New Albany Planning Commission Agenda
Monday, June 20, 2022 7:00pm

**Planning Commission Staff Report
June 20, 2022 Meeting**

LOCATION: 7210 Ebrington Round (PID: 222-004754-00).
APPLICANT: Todd Parker, F5 Design/Architecture Inc.
REQUEST: Variance to West Nine 2 Subarea C zoning text section 4(d) to allow a covered porch to be setback approximately 21.5 +/- feet from the rear property line where the zoning text requires a 30-foot setback.
ZONING: West Nine I-PUD Zoning District
STRATEGIC PLAN: Residential
APPLICATION: VAR-59-2022

Rear Elevation AREA OF PORCH ENCROACHING

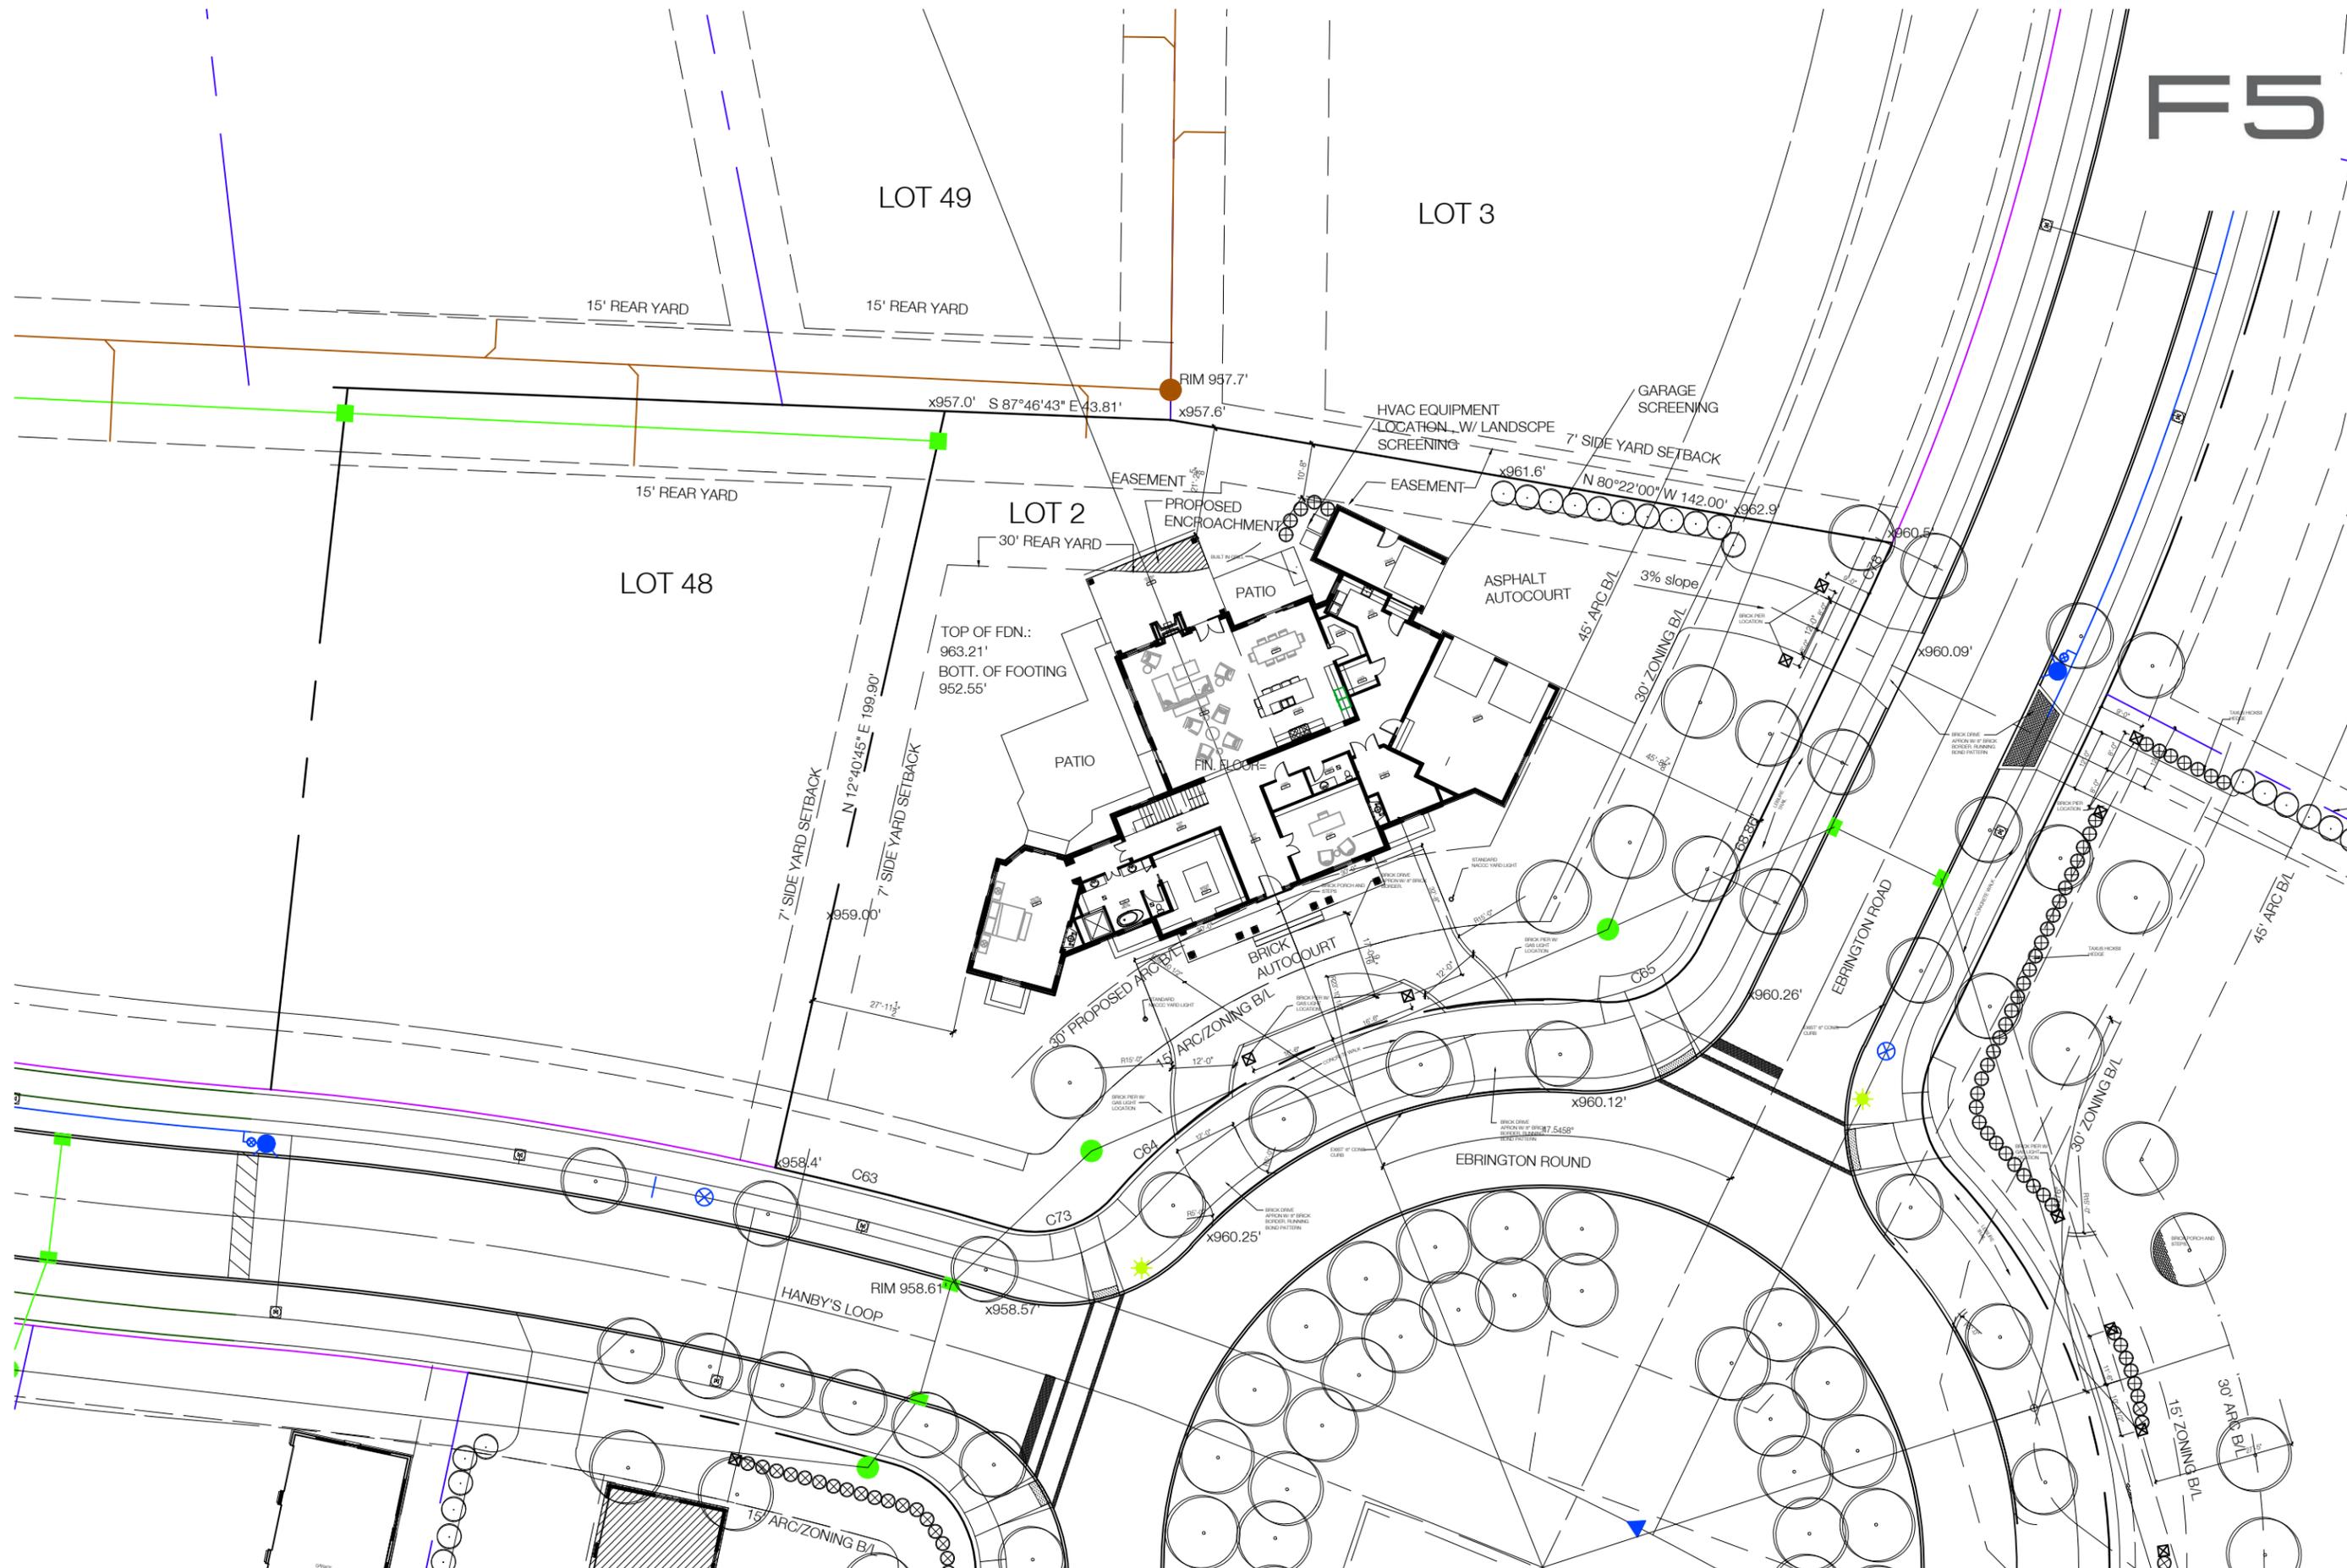
The request is for a rear yard setback encroachment of an attached covered porch. Due to the “triangular” shape of the lot and other site constraints, the rear yard setback as interpreted by the planning and zoning staff impacts the approved (by NACCC ARC) design of the home. The encroachment would be a maximum of 6'-8" and a triangular portion of the porch with amounts to 71 s.f. (19% of the porch area).

- **The literal interpretation of the zoning code would indeed deprive the Homeowner from executing this project and there is precedent in the same zoning district for 15' rear yard setbacks. In this case the corner of the porch in question would create roughly a 21'-6" setback.**

1. Landscaping must be added along the rear and side property line abutting lot 3 where setback encroachment is proposed, subject to staff approval.
